RAIB Report: Lebanon Road - Tram running with doors open on London Tramlink, Croydon

I write to report¹ on the consideration given and action taken in respect of the recommendations addressed to ORR in the above report, published on 6 March 2014.

Picture 1 – Override Safety System

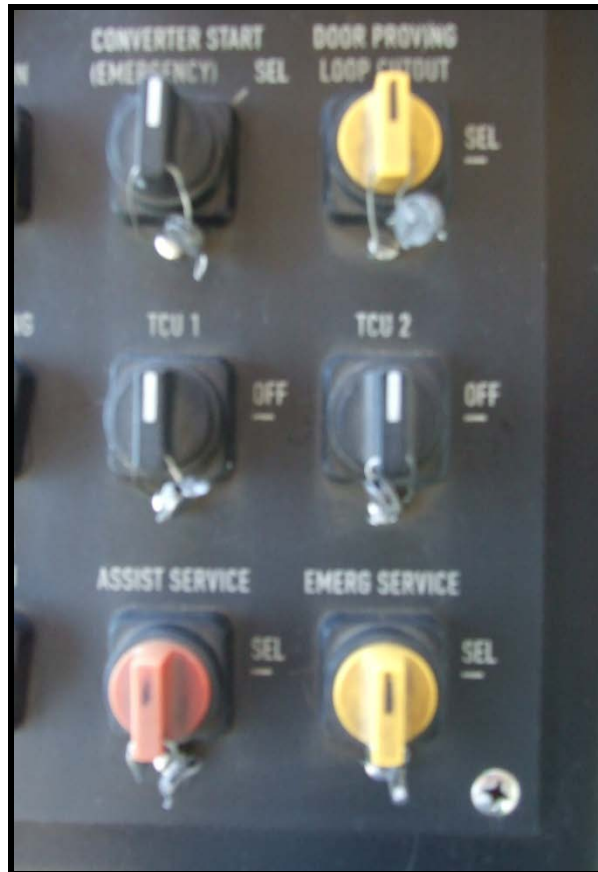
Override Safety Systems (See Picture 1)

Supertram current fleet have 6 safety override switches which are situated to the right hand side of the driver's seat, of which have the following functions:

Converter Start (Emergency) – Requires addition of a battery pack. Drivers are not able to access areas to rectify fault.

Door Proving Loop Cut Out – Bypasses door safety systems. Tram could be driven with doors open when switch has been operated. **DOOR** will be illuminated on the Annunciator panel.

TCU 1 (Traction Control Unit) – This switch may be activated if the tram has a drive fault on the traction control unit at No1 end. The switch will only be activated on instruction from the control room. Operation of the switch will restrict the maximum tram speed. Additional disc braking applies due to regenerative braking not in operation on the isolated end.

TCU 2 (Traction Control Unit) – As above but applies to the No2 end of the tram.

Assist Service–Used when the coupling of trams is necessary. Provides tram to tram communication plus extra torque and braking properties.

Emerg Service (Emergency) – Used to recover a tram with a major fault. Not essential items are inoperative, interior emergency lighting only. Passengers are not transported when in operation. Driver must be accompanied.

As a result of these functions all of the switches are fitted with metal switch seals, which need to be physically broken in order to enable. As a result the switches cannot be accidentally activated. In addition the clear labelling of the override switches helps provide clear communication to the driver regarding what the switch relates to.

Drivers must only activate the switches on the instruction from OCC. If this communication was to be misunderstood and the driver enabled the incorrect switch by accident, there are further controls in place to alert the driver of this. The Annunciator Panel as seen in Picture 2 provides a visual indicator and audible alarm to the Driver in the event of the enabling of Override Safety System switches. The Drivers receive Fault finding training that outlines the meaning of each indication.

Whilst conducting the review, concerns were raised with the strength of the panel lighting due to fading of the section colour and strength of lighting behind screen. Although the light could be seen, this most definitely could be improved. As a result a further action has been raised in order to review the panel display to ensure the control works as designed and remains suitable and sufficient.

In addition the testing of the Override System, the visual indicators and audible alarms are to be included on a Scheduled Vehicle Maintenance regime going forward to ensure the controls continue to work as per the original design.
